# SAN FRANCISCO FIRE DEPARTMENT | FIRE STATION 5

CIVIC DESIGN REVIEW PHASE III INFORMAL REVIEW: FEBRUARY 8, 2016

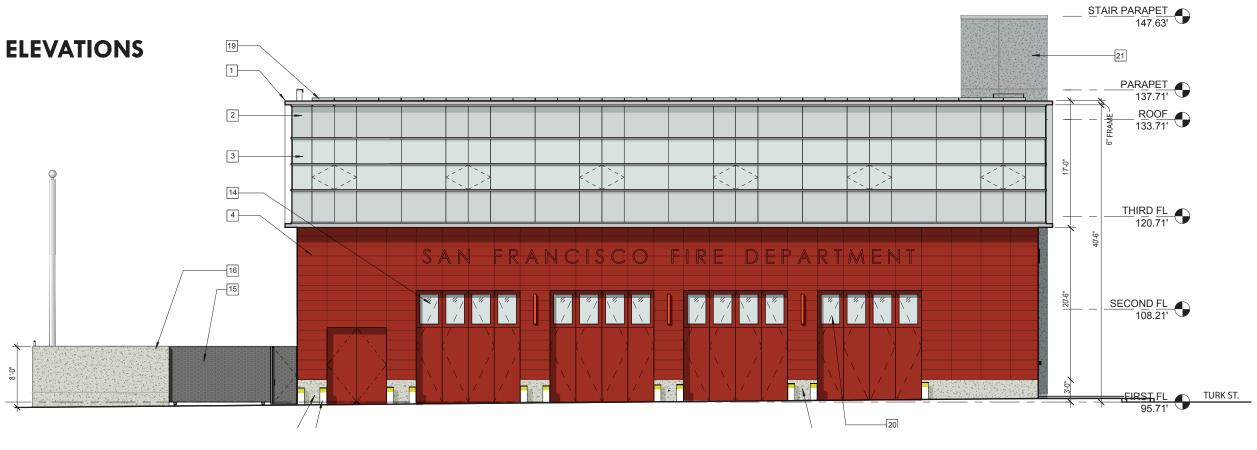
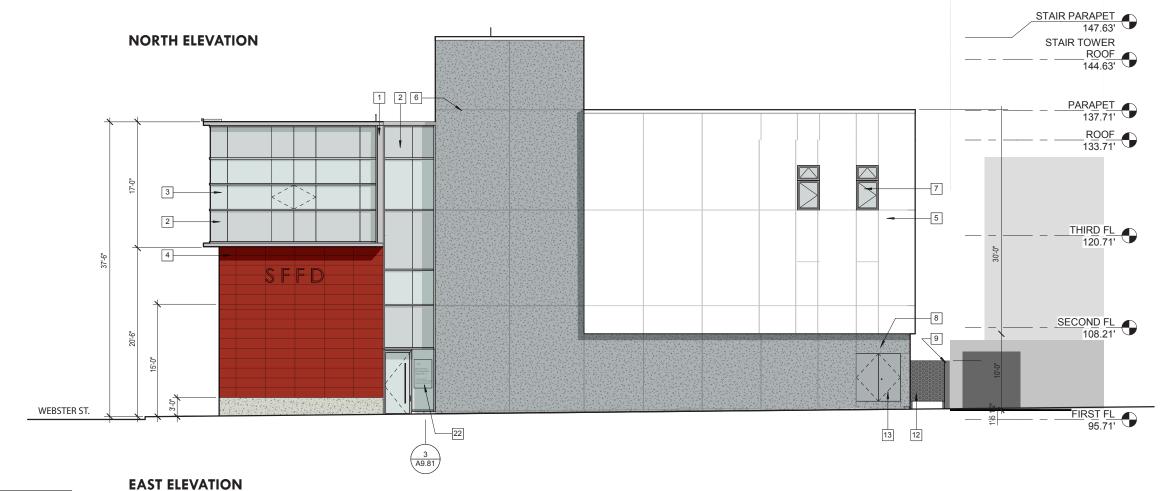
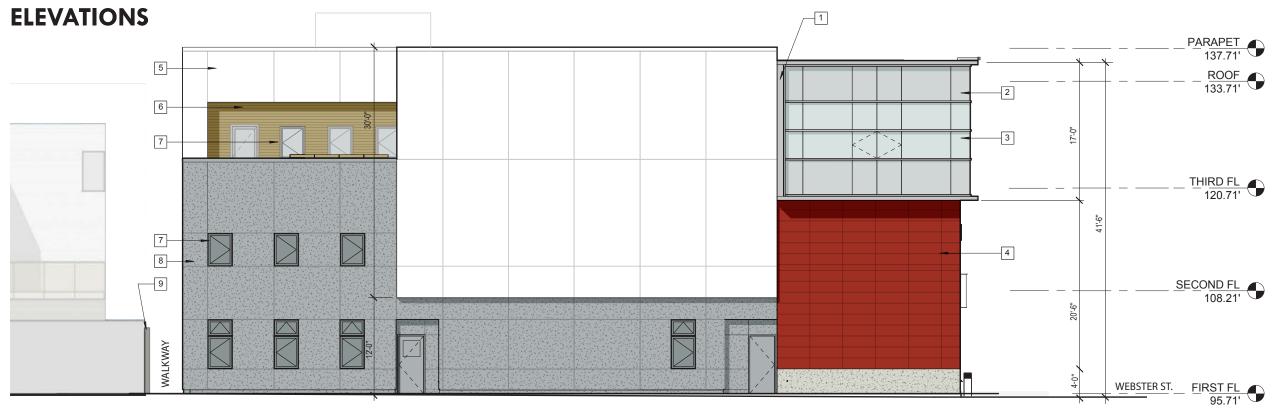
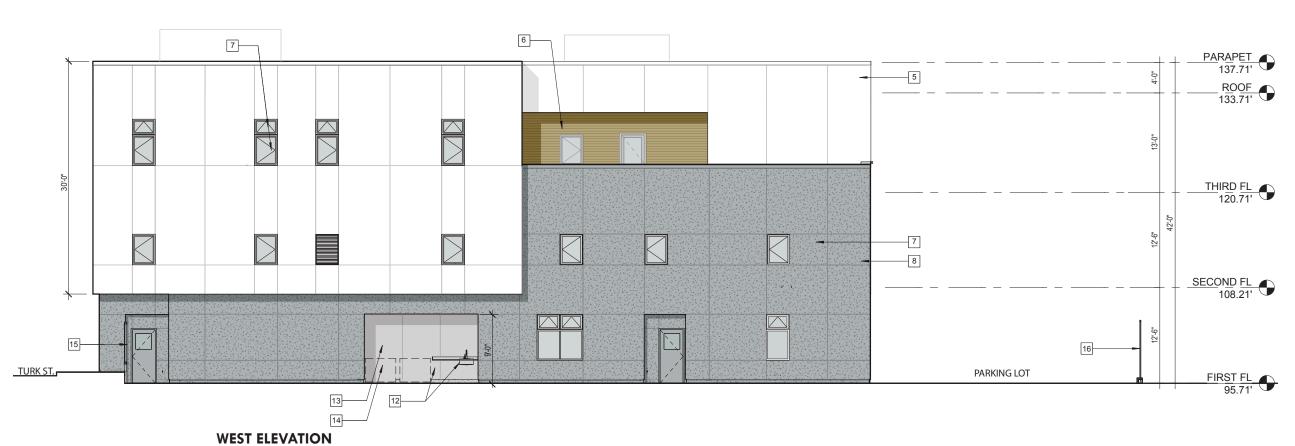
## CDR PHASE II COMMENTS ADDRESSED:

- PROPORTIONS OF CURTAIN WALL TO BASE
- DETAIL CURTAIN WALL, SHOW MULLIONS AND SPANDEL NOT SLICK BOX
- PROPORTIONS OF UPPER WHITE MATERIAL TO GREY BASE
- SIMPLIFY COLORS AND MATERIAL PALETTE
- REPLACE METAL PANEL (RED) WITH A TERRA COTTA/MASONRY/TILE (REFERENCING BACK TO TRADITIONAL SF FIRE STATIONS)
- CONCRETE 'FOOT' ADDED AT APRON TO GIVE FOR EVEN DATUM (REFERNCING BACK TO TRADITIONAL SF FIRE STATIONS)
- LADDER RAIL SHOULD BE INVISIBLE NOT CORNICE-LIKE
- SFFD GRAPHICS SHOULD BE SPELLED OUT

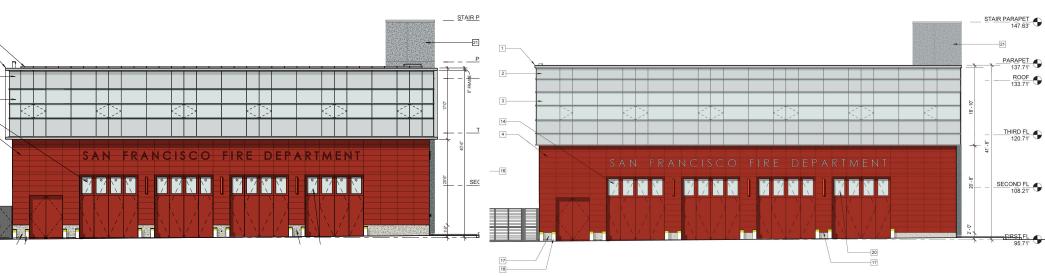
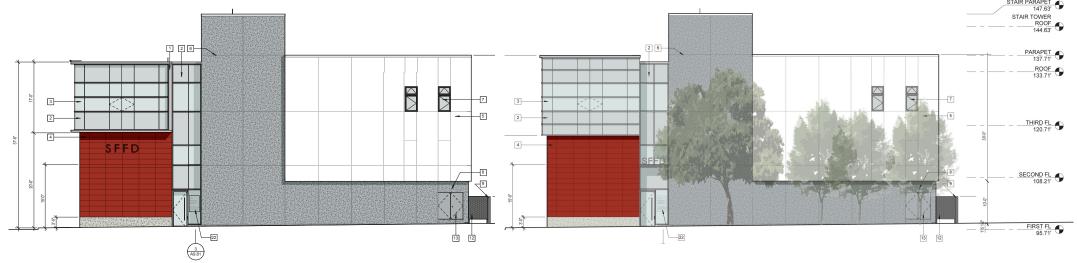
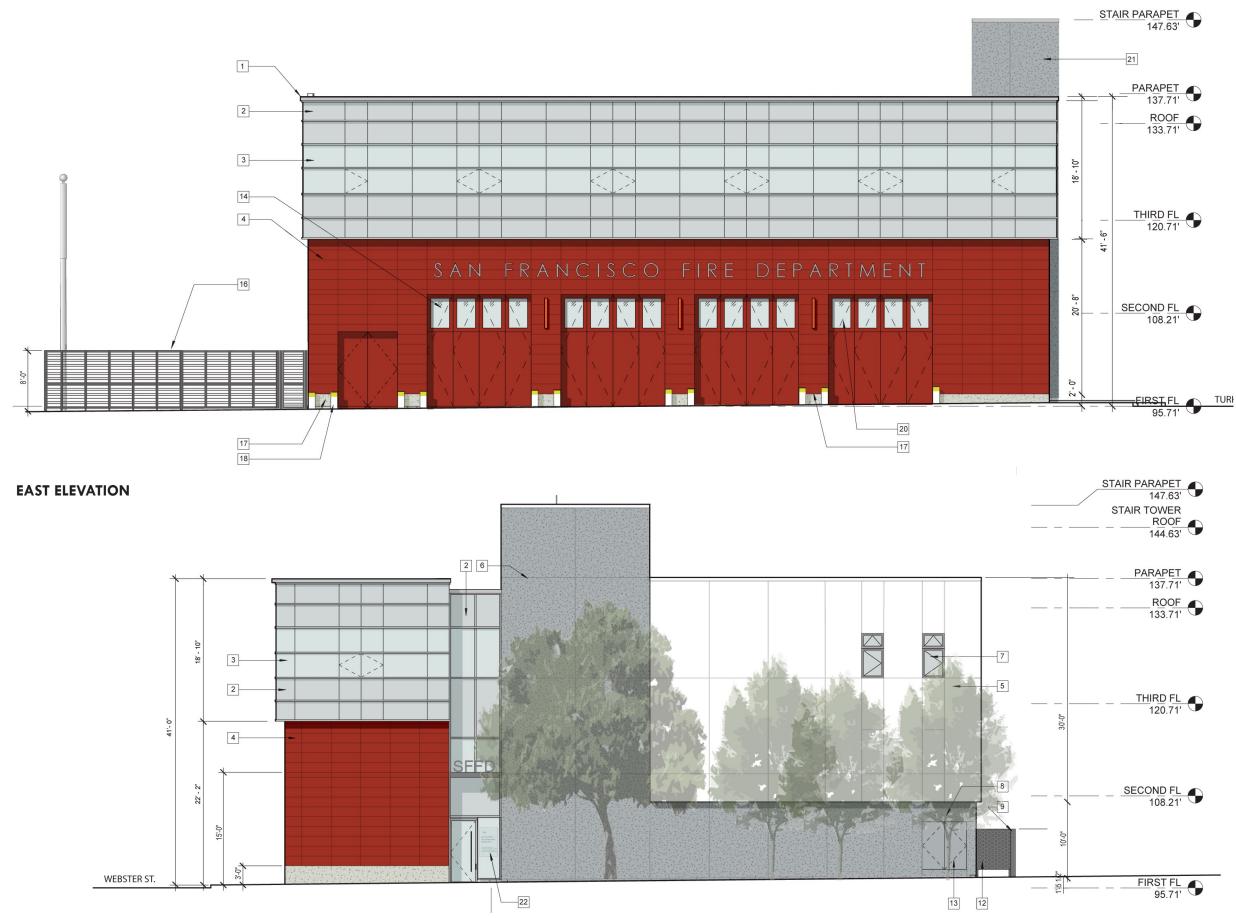
## CDR PHASE III COMMENTS ADDRESSED:

- PROPORTIONS OF CURTAIN WALL TO BASE THOUGHT GLASS BECAME TOO HORIZONTAL
- DETAIL OF CURTAIN WALL; DIDN'T LIKE FRAME AROUND CURTAIN WALL SYSTEM
- REPLACED METAL PANEL (RED) WITH A TERRA COTTA/MASONRY/TILE- ADJUSTED PROPORTIONS TO CURTAIN WALL GLASS

## ADDRESSED PREVIOUSLY FROM PHASE II COMMENTS:

- MADE LADDER RAIL SHOULD BE INVISIBLE NOT CORNICE-LIKE
- SPELLED OUT SFFD GRAPHICS SHOULD BE SPELLED OUT
- SIMPLIFY COLORS AND MATERIAL PALETTE
